S24DG: 7.3L Transmission Oil Cooler Interface Update & Cross Contamination Inspection

Models Affected: BBCV buses with Ford 7.3L / 6R140 with build dates between July 18th, 2022 through November 8th, 2023

Issue: Coolant and Transmission Fluid cross contamination and/or external coolant leaks.

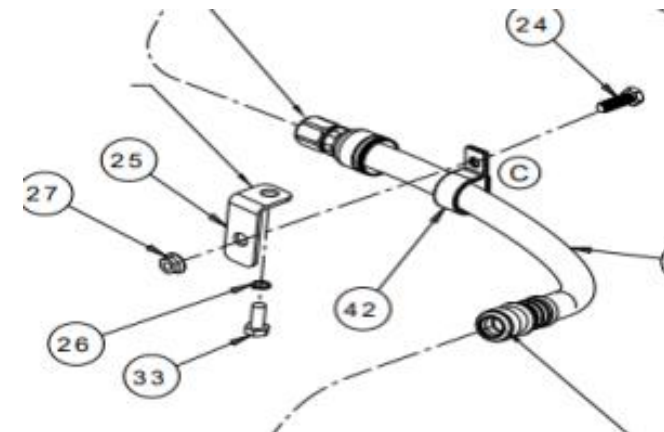
16) Verify P clamp from passenger side cooler line is configured, per the below illustration. Make corrections if not.

18) Replace O-ring on radiator drain with 10081850.

19) Vacuum fill the cooling system reusing the coolant drained if meeting re-use guidelines. Verify system holds vacuum to ensure no coolant leaks.

Post TOC update:

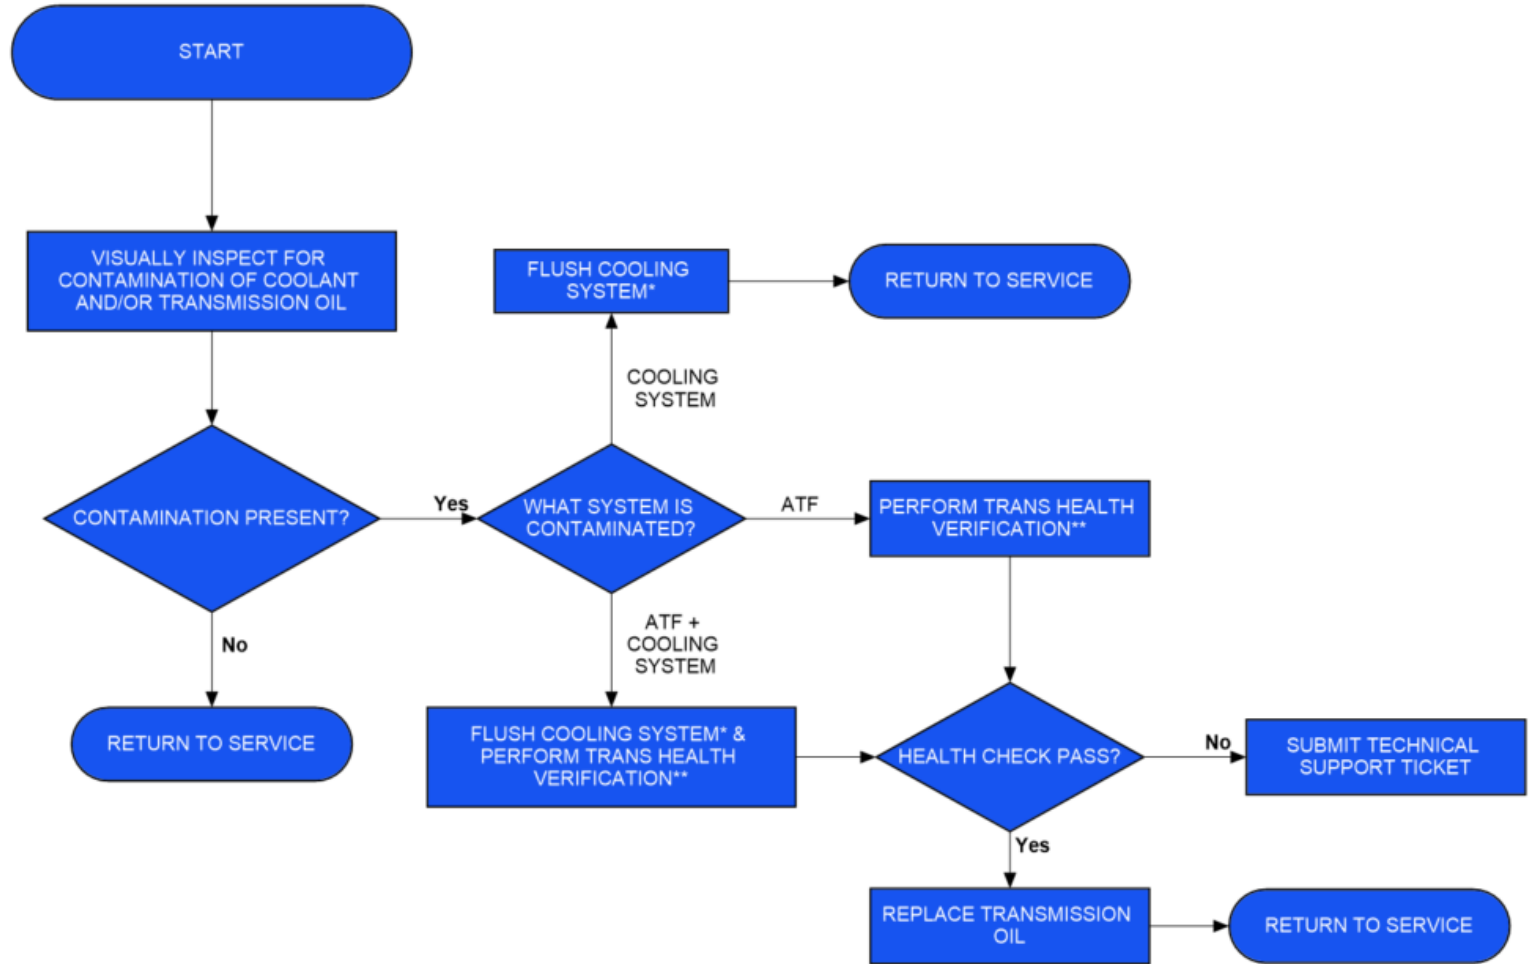
***NOTE:** Visual inspection of the transmission oil plus the IDS trans health check has replaced the use of glycol test strips previously advised on earlier communications.

****NOTE:** Transmission Repair/Replacement made under warranty will require a failed IDS session attached to claim.

Transmission Health Verification

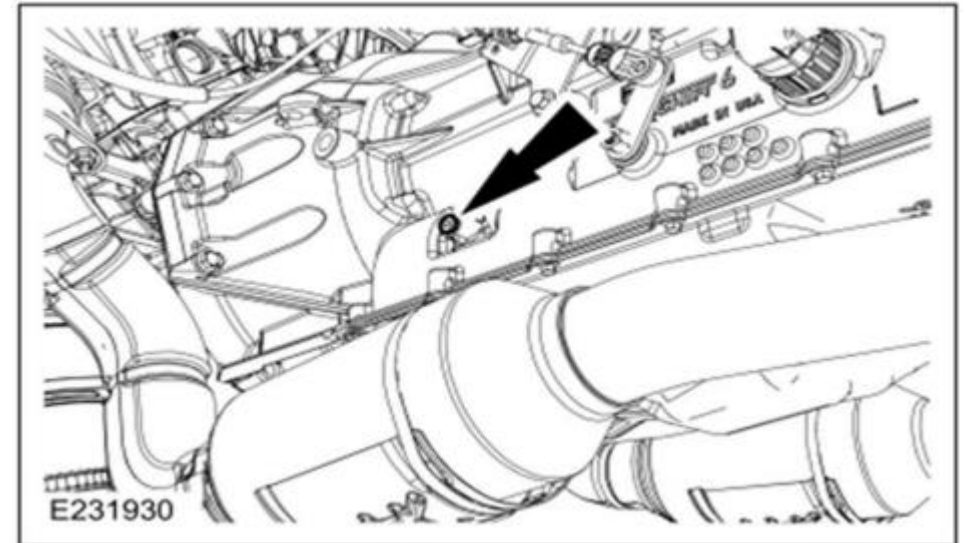
1. Line Pressure Test:

- Connect IDS. Record and clear DTC's.
- Connect 0-400 PSI pressure gauge with M10x1.00 to the line pressure port identified below.
 - **DO NOT use 1/8" NPT or case damage will result.**
- Launch datalogger & monitor PID LINEDSD#.
- Start engine and compare measured line pressure with value displayed on IDS.
- The two should be within 10 PSI of each other.
- Perform this check at variable RPM's in Neutral, Rev, and Drive.
- Continue to Step 2 if passed. If failed, enter technical support ticket noting results.

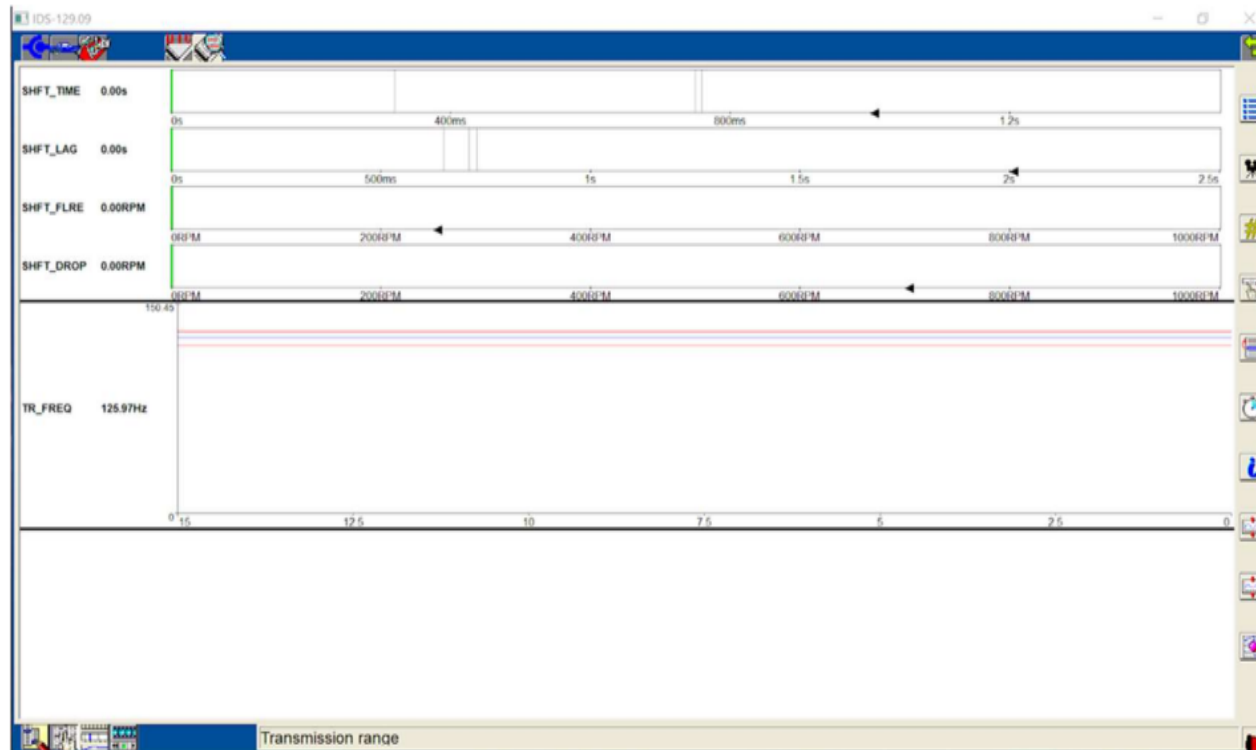
SHFT_DROP - RPM

Set Display Range: High 3000RPM, Low 0RPM. Current value: 1000RPM.

Set Limits: Upper 3000RPM, Lower 0RPM. Current value: 100RPM.

SHFT_LAG - s

Set Display Range: High 6s, Low 0s. Current value: 2.5s.

Set Limits: Upper 6s, Lower 0s. Current value: 1.2s.

SHFT_TIME - s

Set Display Range: High 6s, Low 0s. Current value: 1.5s.

Set Limits: Upper 6s, Lower 0s. Current value: 1s.

TR_FREQ - Hz

Set Display Range: High 512Hz, Low 0Hz. Current value: 150.45Hz.

Set Limits: Upper 512Hz, Lower 0Hz. Current value: 130.39Hz.
